**Simplification of lighting and light-signalling UN Regulations:****UN Regulation No. 149 (Road illumination devices)**

**Other UN Regulations:****UN Regulation No. 53 (Installation of lighting and light-signalling devices for L<sub>3</sub> vehicles)****Proposal for new Supplements to UN Regulation No. 53 and  
UN Regulation No. 149****Submitted by the expert from the International Motorcycle  
Manufacturers Association\***

**Figure**  
Scope of application of AFS requirements

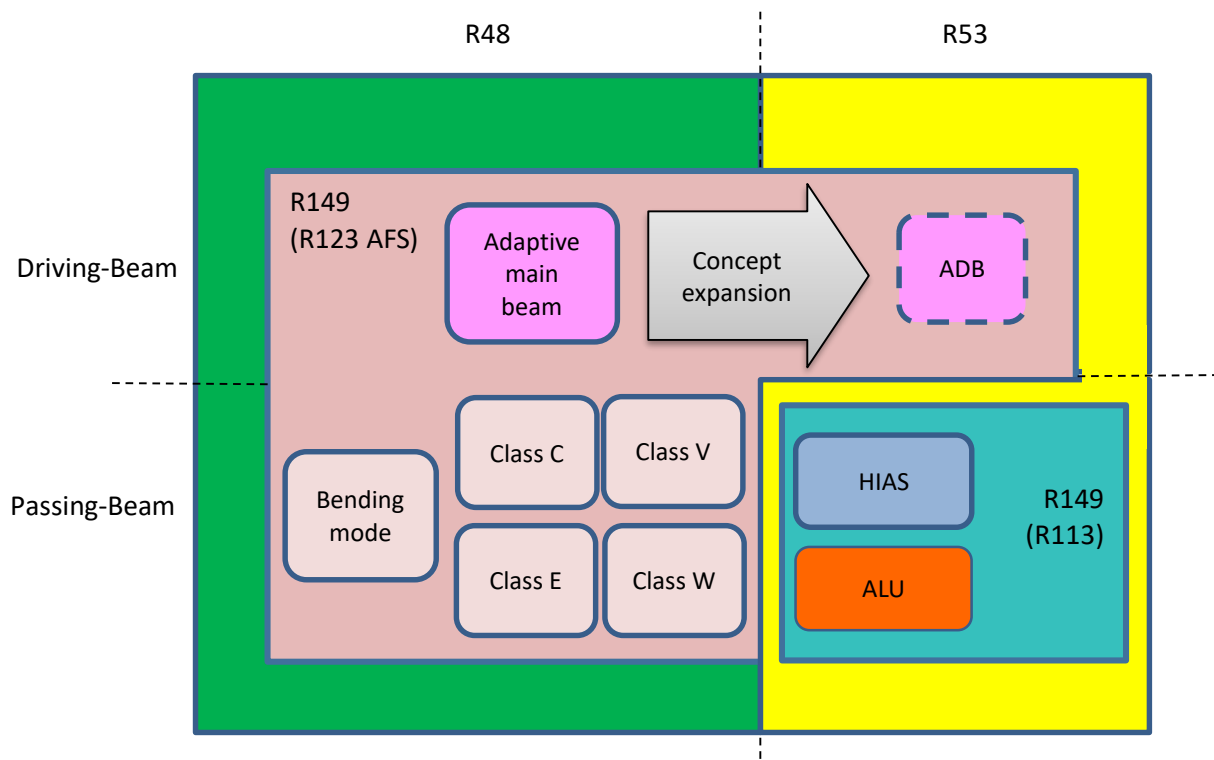
4. For consistency with the proposal for UN Regulation No. 53, limiting the allowance to install ADB to vehicles of category L<sub>3</sub>, it is proposed to add “ADB for vehicles of category L<sub>3</sub>” in the scope of UN Regulation No. 149. Given that, by definition, AFS requirements would apply to ADB, specific references to ADB for vehicles of category L<sub>3</sub> are proposed where necessary, minimising the number of amendments to UN Regulation No. 149.

8. The image below illustrates the proposed expansion of the scope of application of AFS requirements.
